L-2010-065
10 CFR 50.90

Re: Turkey Point Units 3 and 4
Docket Nos. 50-250 and 50-251
Response to Request for Additional Information (RAI) Regarding Alternative
Source Term (AST) License Amendment Request (LAR) 196 (TAC NOS.
ME1624 and ME1625)

Response to 03/24/2010 Request for Additional Information (RAI) Regarding Alternative
Source Term (AST)

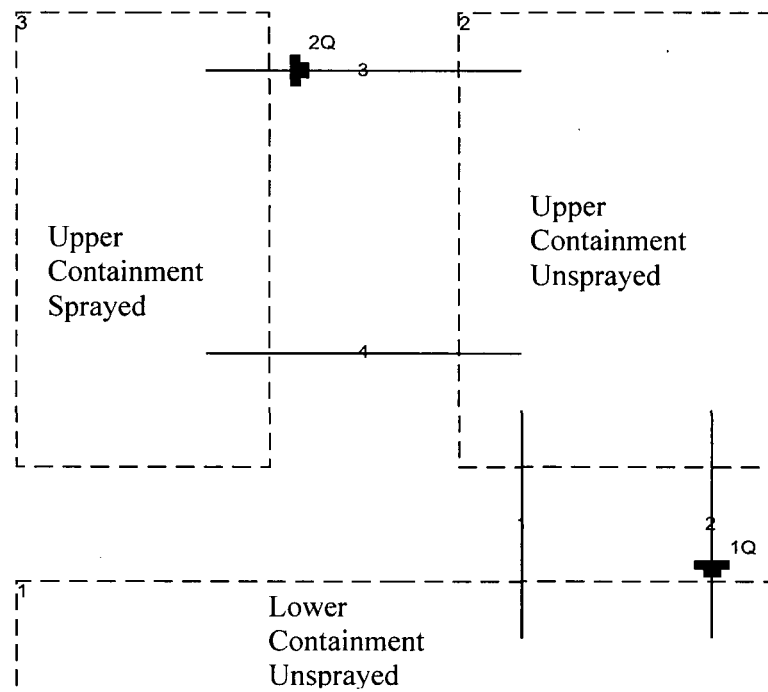
c. Describe how the equivalent mixing flow rates for the lumped model were determined.

A three volume lumped model was constructed that includes the lower containment unsprayed region, the upper containment unsprayed region and the upper containment sprayed region. The volumes were interconnected by flow paths as shown in the following figure.

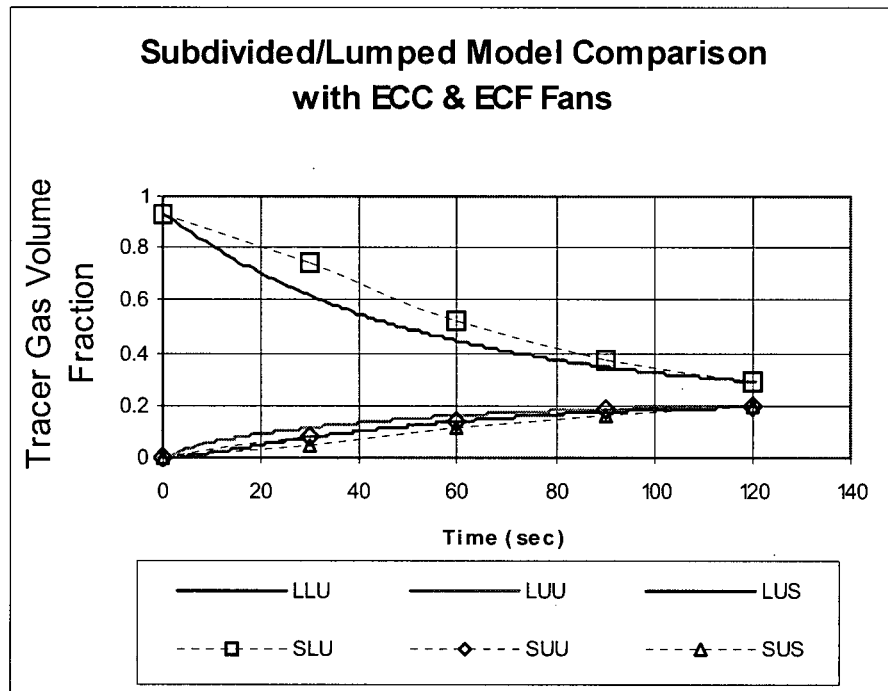
- d. Describe the relationship between the equivalent mixing flow rates that were determined for the lumped model with the mixing flow rates in the subdivided models.

The fan flows in the lumped model were adjusted so that the tracer concentration in each of the 3 lumped volumes approximately matched the volume average gas concentrations in each of the three equivalent regions in a subdivided model after two minutes of operation. Typical results for the concentration transient are shown in the following figure.

LLU, LUU and LUS refer to Lumped model-Lower containment Unsprayed, Lumped model-Upper containment Unsprayed and Lumped model-Upper containment Sprayed, respectively. SLU, SUU and SUS similarly refer to corresponding regions in the subdivided model. It is evident from this graph that the mixing rate near the beginning of the run, indicated by the slopes of the concentration curves, is not as high in the subdivided model as it is in the lumped parameter model. This is because it takes a finite amount of time for the flow patterns to be established in the subdivided model. In the lumped parameter model, on the other hand, the fans are brought to full flow almost instantaneously and perfect mixing is assumed in each lumped volume. By the end of the run, mixing rates in the subdivided model have increased beyond the constant values used in the lumped parameter model, resulting in identical concentrations at that point in the transient. Matching the subdivided and lumped parameter model concentrations in this way resulted in a conservative estimate of the effective mixing rates calculated by the subdivided model.

Figure 1 – Meteorological Tower Location

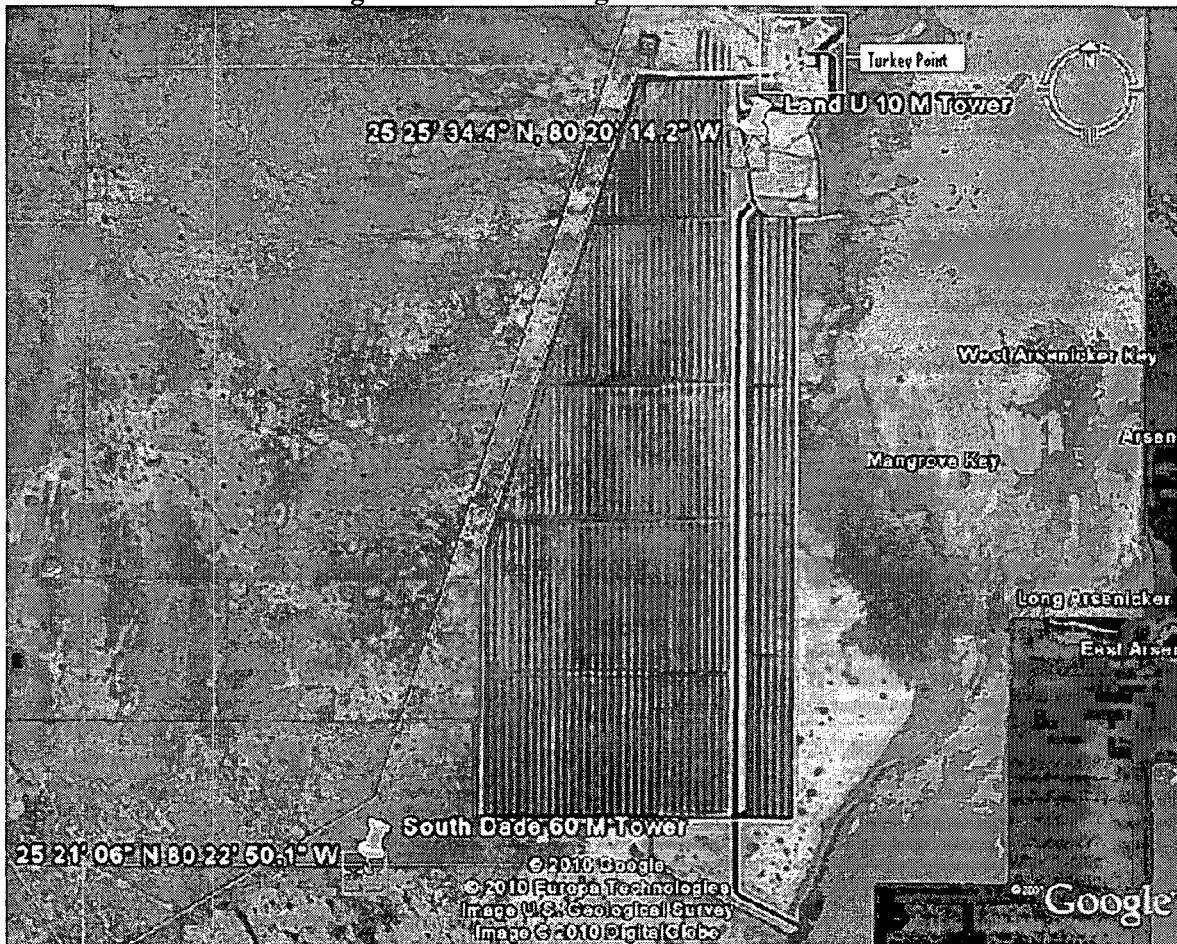
10. What are the heights above ground of all wind direction, wind speed and temperature difference measurements used in the analysis to support the June 25, 2009 AST LAR. Page 15 of Attachment 3 to the LAR states that wind speeds are measured at a height of

11.58 meters above ground. Page 16 cites a 10 meter wind speed. Were all measurements made on a single tower and the reference to 10 meters is simply a convenient approximation to data measured at 11.58 meters (m)? NRC staff noted a relatively lower occurrence of winds from the north northeast direction than from the north and easterly directions between 2003 and 2007. To what may this be attributed? Provide a drawing or provide a reference to an existing docketed drawing which shows the location of the Turkey Point meteorological tower(s) with respect to plant structures and site features.

Based on field measurements performed on September 18, 2002, the height from the bottom of the concrete pad to the height of the wind direction and speed sensors is 38 ft, or 11.58 meters. The measured height from the bottom of the concrete pad to the height of the temperature sensors is 34 ft, or 10.36 meters. All measurements were made on a single tower, and the reference to "10 meters" is simply a convenient approximation of the more precise measurements.

The 10 meter meteorological data for the time period between 2003 and 2007 shows a relatively low occurrence of winds from the north northeast direction compared to that from the northern or easterly directions. It has been determined that this wind pattern is correct and reflects actual meteorological conditions. Comparison of 10 meter and 60 meter wind direction data from the South Dade meteorological tower correlated well as did comparison with the 10 meter data from the Land Utilization meteorological tower. Comparison with wind direction data from the Miami International Airport yielded similar results and substantiated this observed wind pattern. See Figure 1 for an aerial view of the South Dade and Land Utilization Meteorological Tower locations relative to the site.
